Compliance Assessment Report for: CAR_NRW0048997

Permit number	EPR/BX9471IU	Operator name	Tata Steel UK Limited
----------------------	--------------	----------------------	-----------------------

Site name	Trostre Works
Site address	Trostre, Llanelli, Carmarthenshire, SA14 9SD
Type of assessment	Site inspection

Date of assessment	29/07/2025	Time in	10:20	Time out	13:15
---------------------------	------------	----------------	-------	-----------------	-------

The four sections have been shown in the aerial view screenshot of the flume below (marked in red, orange, green and blue).

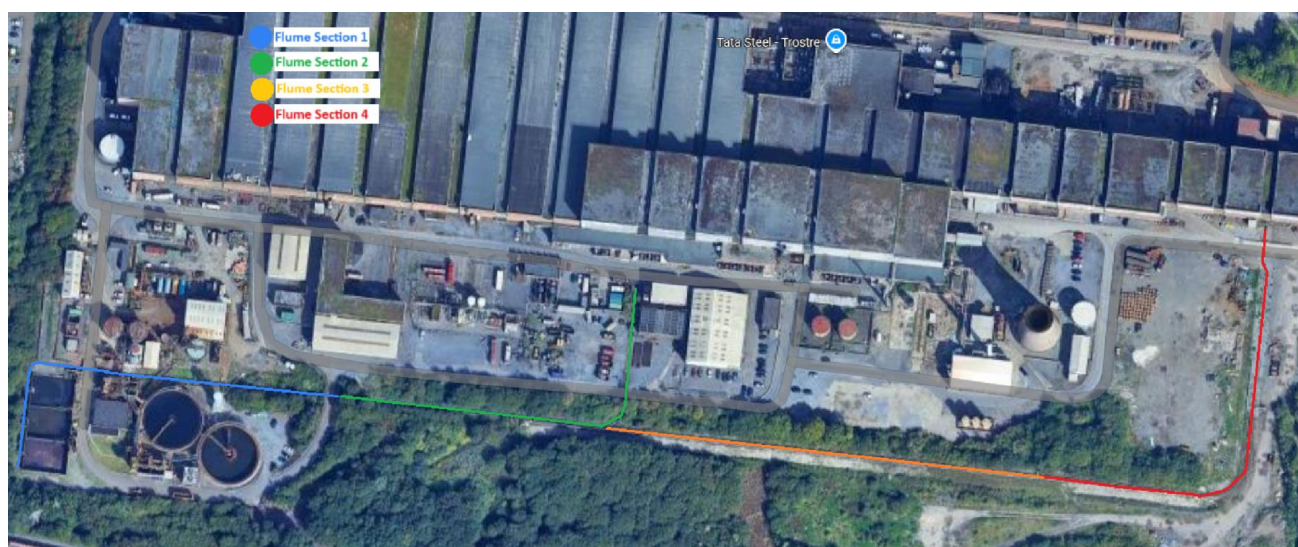
TSUK confirmed a new annual inspection program for the flume has been created and is implemented onto the Concept system/SAP system. The new planned preventative maintenance task is an internal inspection of a section of the flume (once dammed and cleaned), to visually check the chemical resistant lining across the walls and base of the flume.

The flume will be divided into four sections, with one section being inspected every year⁶.

- Carry out an annual inspection of the flume, to visually check the chemical resistant lining across the walls and base of the flume. The flume will be divided into four sections, with one section being inspected every year.
- NOTE – TSUK must review the programme regularly in conjunction with NRW and may be subject to changes in inspection frequencies e.g if more deficiencies are identified, an increase inspection frequency may be required.

Image 1 & 2 – Liner underneath clarifiers.

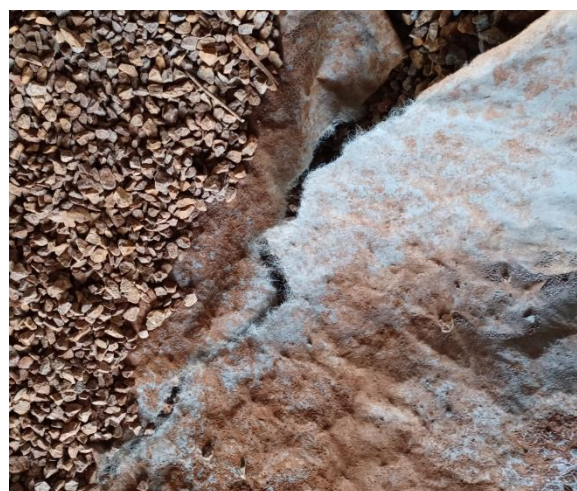
Upon inspection, the liner, now clearly visible beneath the clarifiers, was found to be in poor condition. Numerous tears and holes were evident, and sections of the liner material were unsealed. The material of the liner appeared to be that of a geo-textile membrane, as opposed to a more robust chemically resistant containment plastic liner which was initially described to NRW. Therefore, it is considered there is a lack of containment by appropriate measures and the unauthorised emission of polluting substances had the potential to have a significant impact or effect on the environment, people and or/property (as identified in CAR__NRW004792).

TSUK are considering their next steps into the liner replacement or alternative solution and will warrant further discussion with NRW.
